FINAL DRAINAGE REPORT

FALCON RANCHETTES FILING NO. 2
MERIDIAN STORAGE
El Paso County, Colorado

Add PCD File No.
VR239

DATE:
April 24th, 2023

Figure 3-2
 Drainage Basin Map
 Falcon DBPS
 El Paso County, CO

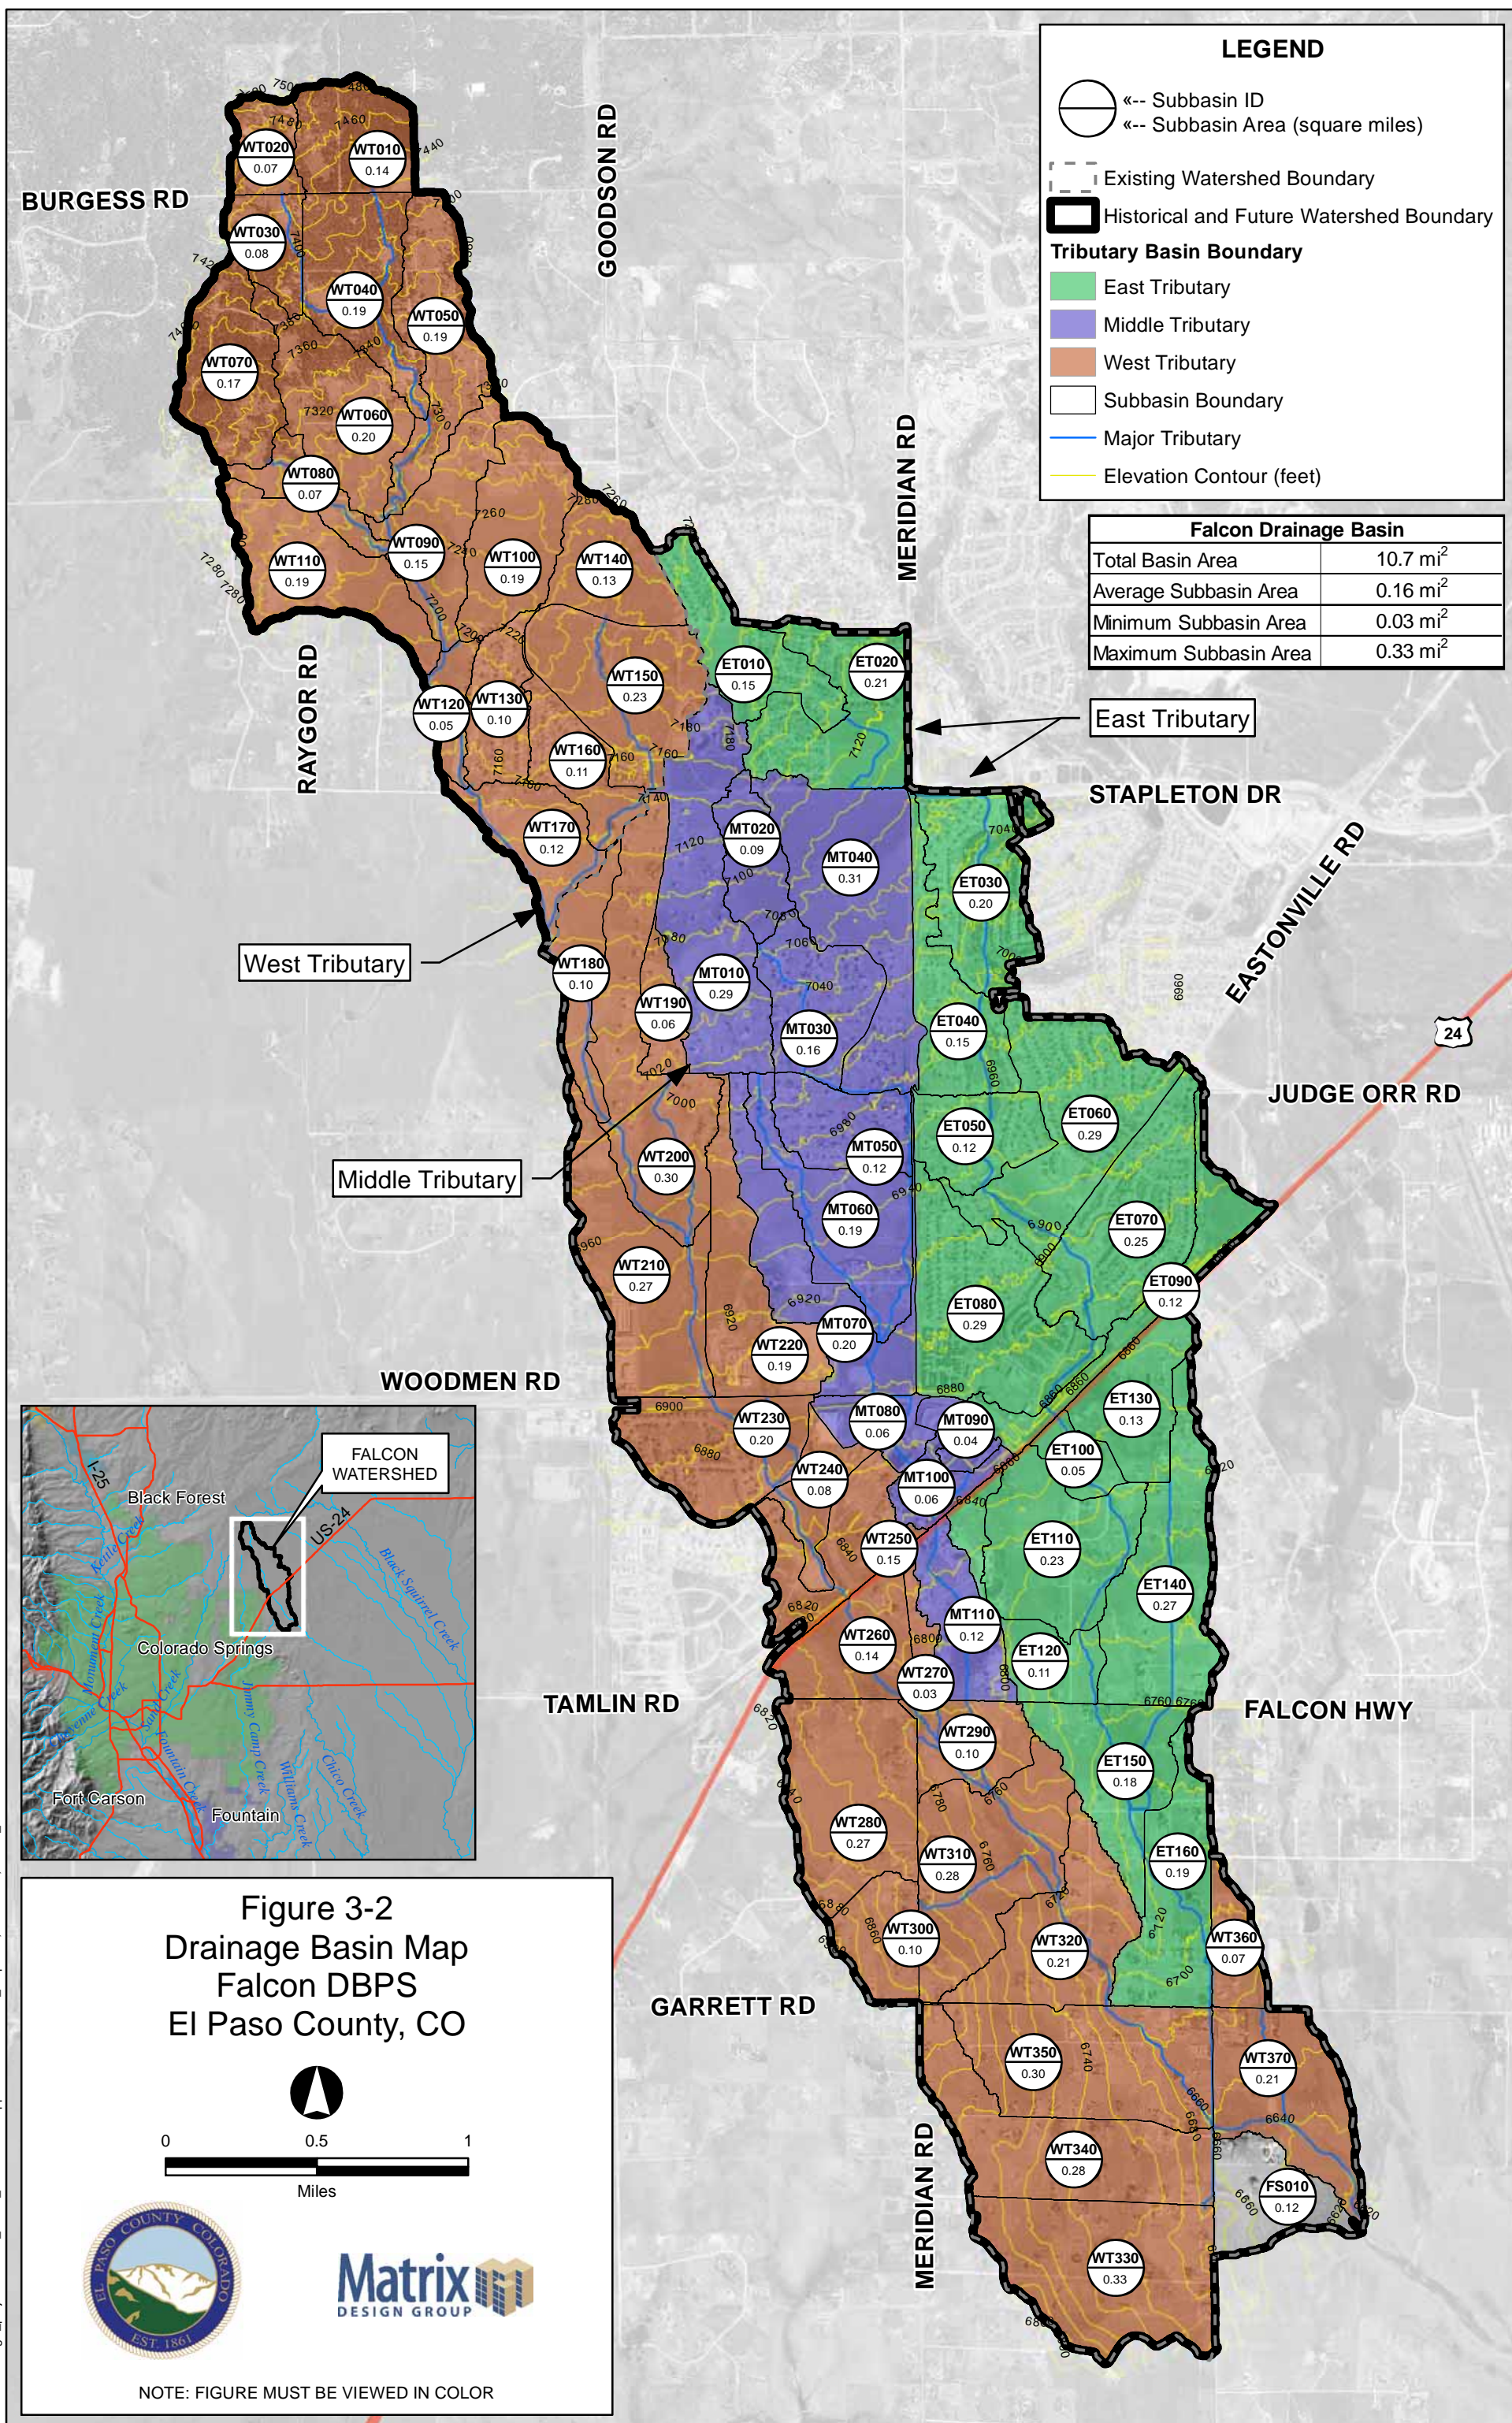
Fix figure - entire background show up as black making the figure difficult to read.

Project: Meridian Storage
 Inlet ID: DP4

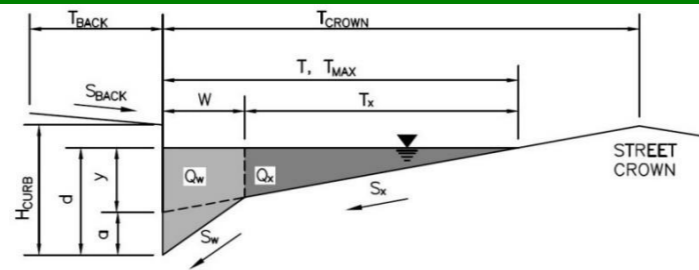
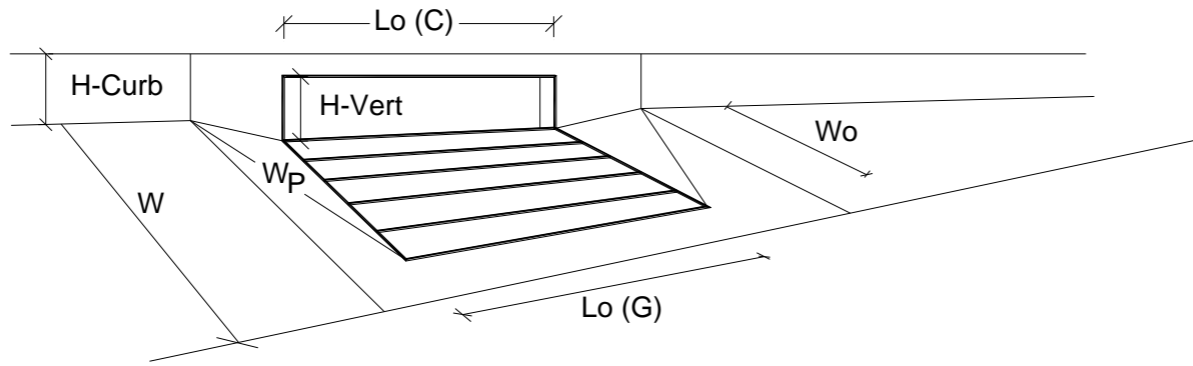
The narrative indicates that Basin B-3 flow is conveyed to this inlet. The flow at basin B-3 is 4.7cfs/8.1cfs (5yr/100yr). Please revise accordingly as it does not appear that the entire flow is being accounted for in this design.

REVISED BASINS AND CORRECTED INLET CALCS.

DETENTION BASIN STAGE-STORAGE TABLE BUILDER

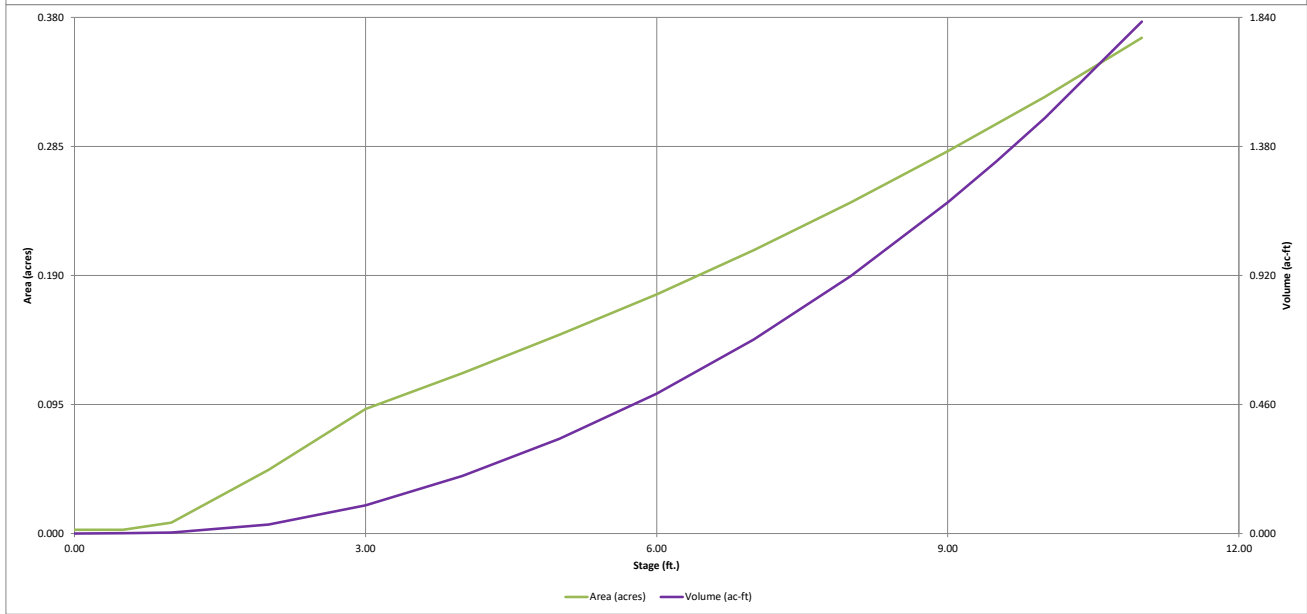
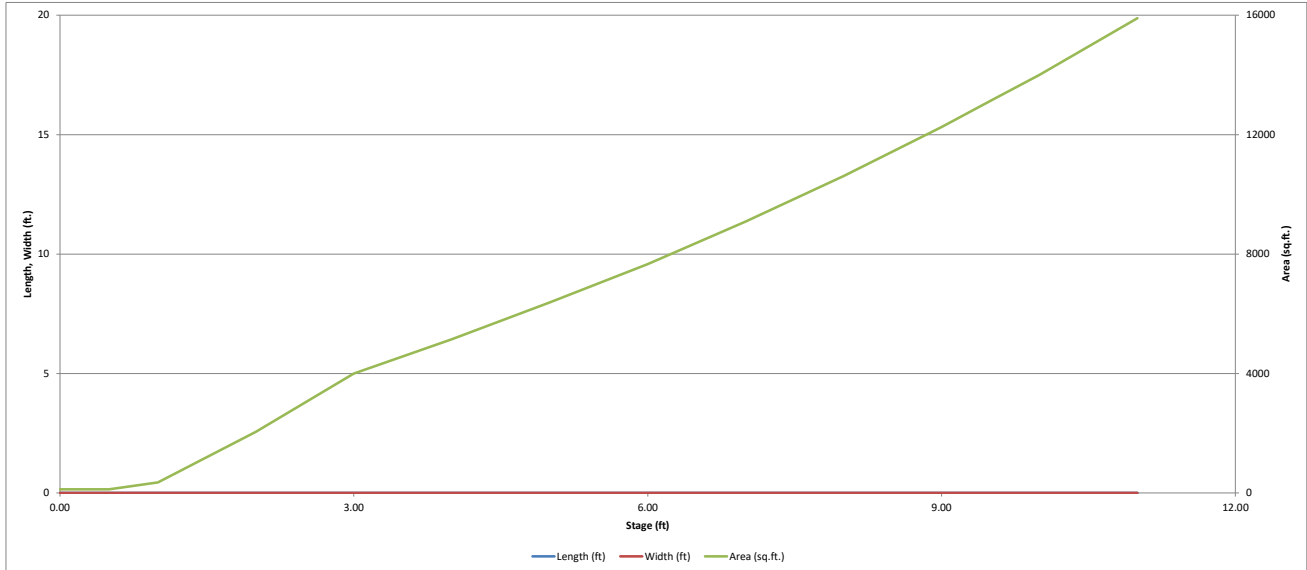
Pond details show 4.79'. Verify and update

3.42 per pond details. Verify and update so both match.

Pond details show 1.75'

Pond details call out 1.16'. Verify and update so both match.

Pond details show 30" RCP

Side slopes are not shown on plans. Update and verify both match.

REVISED SO PLAN AND CALCS MATCH

REVISED SO PLAN AND CALCS MATCH

REVISED SO PLAN AND CALCS MATCH

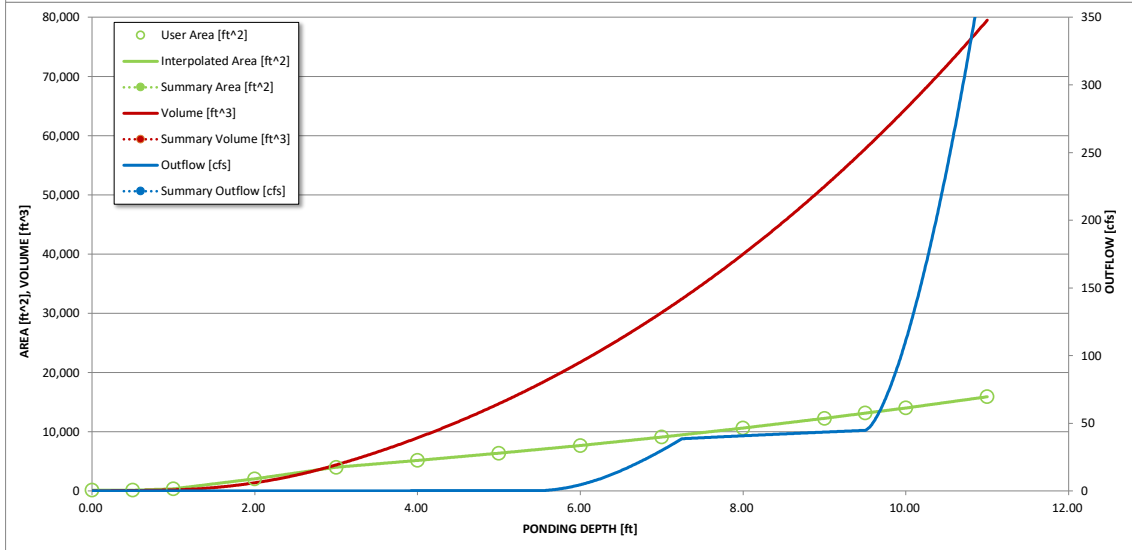
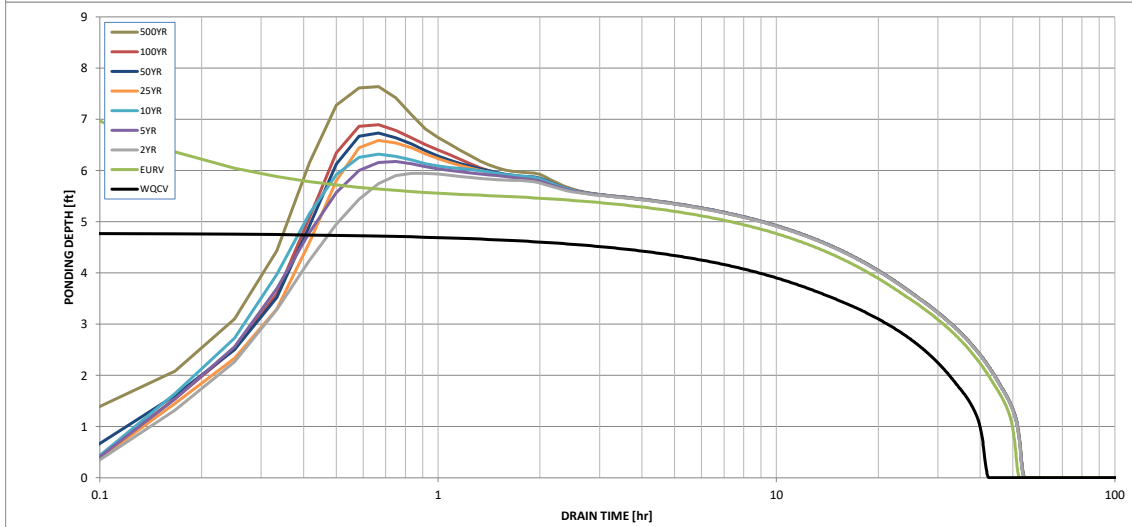
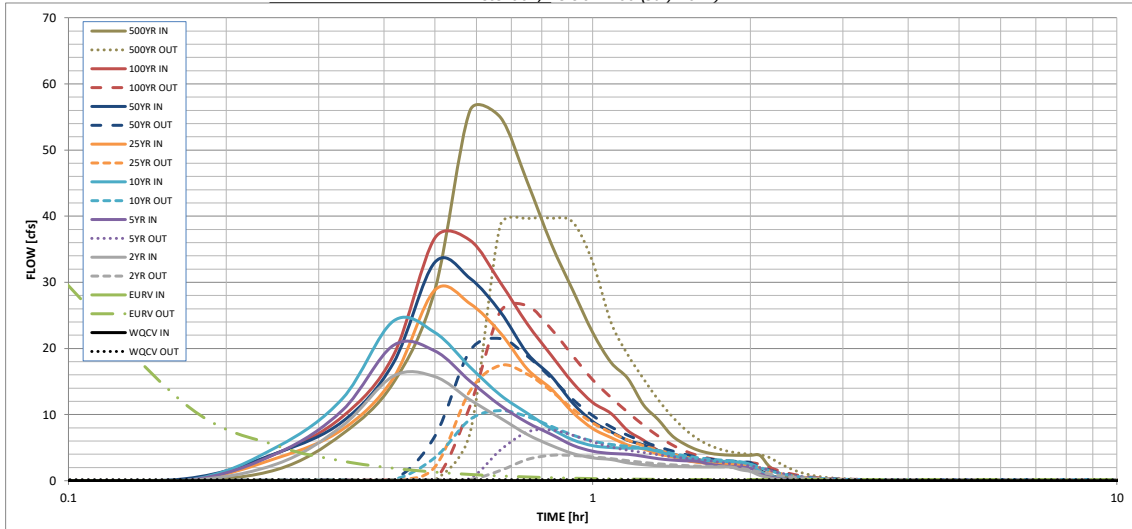
this flow seems very high, please confirm

add a note stating that detention will be addressed with regional pond

REVISED TO FULL SPECTRUM
